# Groundwater Transfer Review Summary Form

Transfer/PA # T- 13361

Application: T-13361

Applicant Name: Osprey Corner, LLC

## Well Location Map

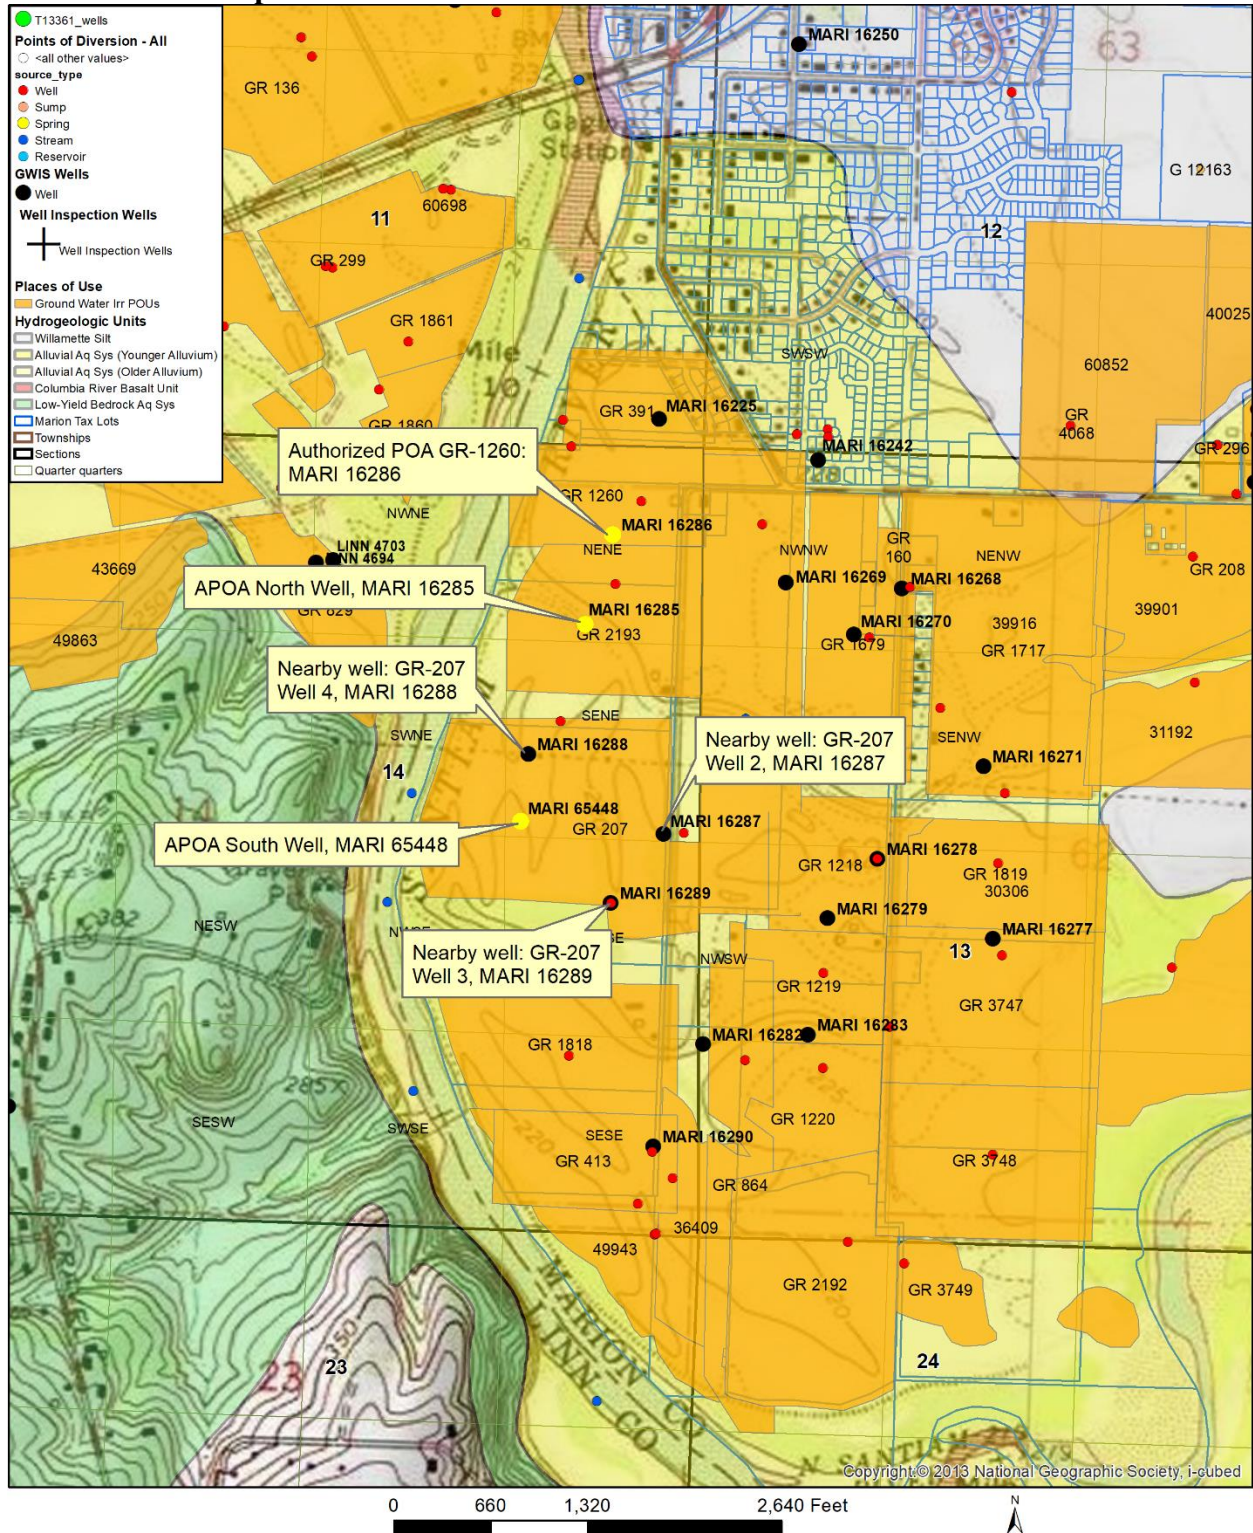
- The application notes that GR-2193 appears to have referenced the well and POU locations by incorrectly assuming that the NE corner of Section 14 was at the NW corner of Weddle Road and that the north-south portion of Weddle Road was the section line between sections 13 and 14. We agree that this is true based on a review of information in file GR-2193 and the associated registration statement. The well locations on the enclosed map reflects the best known locations of the authorized POA and the proposed POA.

☒ Yes ☐ No Comments: The proposed APOAs will be closer than the authorized POA to several nearby wells listed on claim GR-207 (MARI 16288, MARI 16287, and MARI 16289). This will result in more hydraulic interference at these adjacent wells (although all are also owned by Osprey Corner, LLC).

☐ Yes ☒ No If yes, explain: APOA MARI 65448 is about 460 feet from MARI 16288 (the nearest well on another water right) and about 660 feet from the river. APOA MARI 16285 is about 960 feet from MARI 16288 and about 640 feet from the river. Although the floodplain aquifer is relatively thin (saturated thickness appears to be 25-35 feet), the aquifer is unconfined and hydraulic conductivity is likely to be high (probably no less than 500 ft/day). In addition, the river is expected to approximate a fully penetrating stream which should buffer hydraulic impacts to nearby wells. Using conservative hydraulic parameters (saturated thickness = 25 feet,  $K = 500$  ft/day, and  $S = 0.1$ ), a Theis interference model (Theis (1935) with a stream boundary (Lohman, 1972) indicates a maximum interference (after 240 days of continuous pumping) of about 1.2 feet at MARI 16288 for each cfs pumped from MARI 65448. The well log for MARI 65448 indicates a maximum pumping capacity of 500 gpm (1.1141 cfs) at the time the well was drilled in 2014. This suggests that the well is unlikely to produce much more than 1 cfs as a new POA on this claim. Similarly, modeled impacts to MARI 16288 from the pumping of APOA MARI 16285 are about 0.55 feet per cfs pumped after 240 days of continuous pumping. The well log for MARI 16288 indicates a maximum pumping capacity of 300 gpm (0.6684 cfs) at the time the well was drilled in 1955. These results indicate that the combined interference from both wells is likely to be no more than 1.7 feet during the irrigation season ( $1.1141 \text{ cfs} * 1.2 \text{ ft/cfs} + 0.6684 \text{ cfs} * 0.55 \text{ ft/cfs} = 1.7 \text{ feet}$ ), which is only a small fraction of the saturated thickness of the aquifer. Wells at greater distances will see even less interference.
